UNITED STATES PATENT AND TRADEMARK OFFICE

| APPLICATION NO. | FILING DATE | FIRST NAMED INVENTOR | ATTORNEY DOCKET NO. | CONFIRMATION NO. |
|---------------------------|-------------|----------------------|---------------------|------------------|
| 10/797,501 | 03/10/2004 | Jeffrey Dunaway | LA144/000LA-U | 3978 |

| Office Action Summary | Application No. | Applicant(s) |

ATTACHMENT

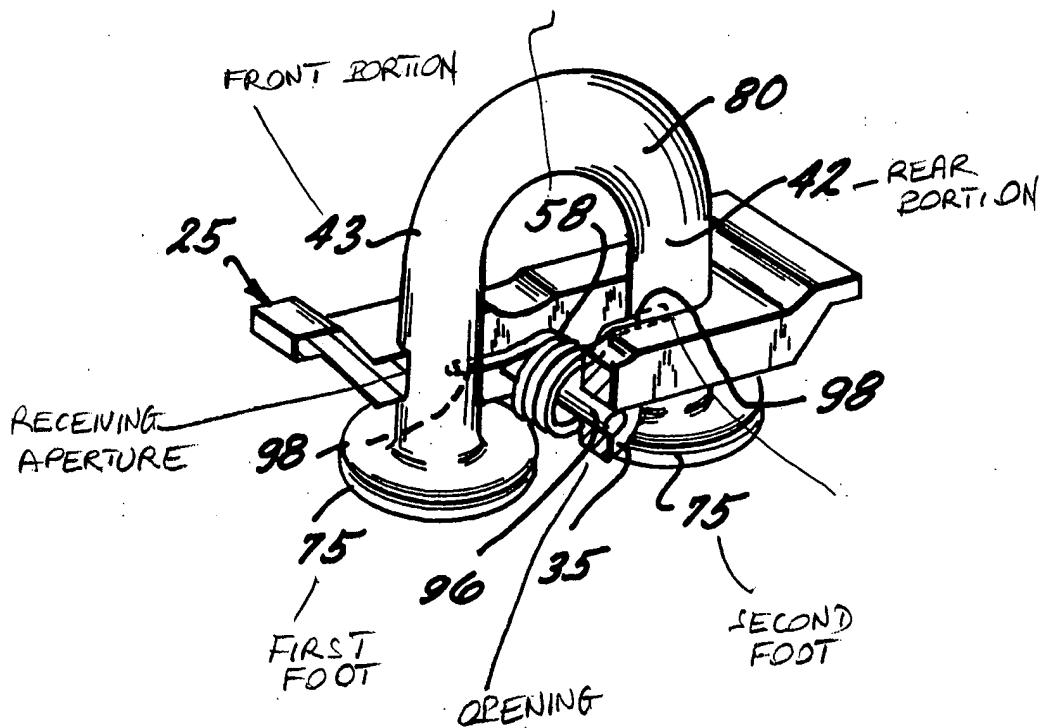
a body 40, 80 having a front portion 43 and a rear portion 42, said rear portion 42 being substantially C-shaped and having a first integral foot 47/75 (see Attachment hereinafter "Att.") and a second integral foot 46/75, said first and second feet 47/75 and 46/75 defining an opening therebetween (Att.), said opening being capable of receiving and securing the covering, at least one of the feet 46/75 and 47/75 for being received in one of a series of openings 20 defined by the track 10, and

a plunger 25 having a lower end 35 and defining a front portion receiving aperture 32, 98, said plunger 25 cooperating with said front portion 43 between a first position (shown in phantom or dashed line in FIG. 2) and a second position (shown by solid line in FIG. 2), said front portion receiving aperture 32, 98 receiving said front portion 43, said plunger lower end 35 being disengaged from the track 10 when said lower end 35 is pulled upwards to the first position (FIG. 2)" allowing movement of the track fitting 15 along the track 10 (FIG. 3), and said lower end 35 engages the track 10 at one of the openings 20 defined by the track 10 when said lower end 35 is placed in the second position (FIG. 4) preventing further movement of the track fitting 15 along the track 10. *Ibid.* col. 4, line 13+ and Claims 1-5.

Claim 1 and other claims below are anticipated by McLennan because McLennan teaches each positively claimed element in the claim. Note that McLennan's front and rear portions of the body 40, 80 are formed as one-piece, therefore, McLennan's rear portion/front portion has first and second feet or *vice versa*. On the other hand, referring the track fitting to the intended use elements, such as, the track, the item, and the covering is not accorded patentable weight. It is well settled that a recitation of the intended use of the claimed invention must result in a structural difference between the claimed invention and the prior art in order to patentably
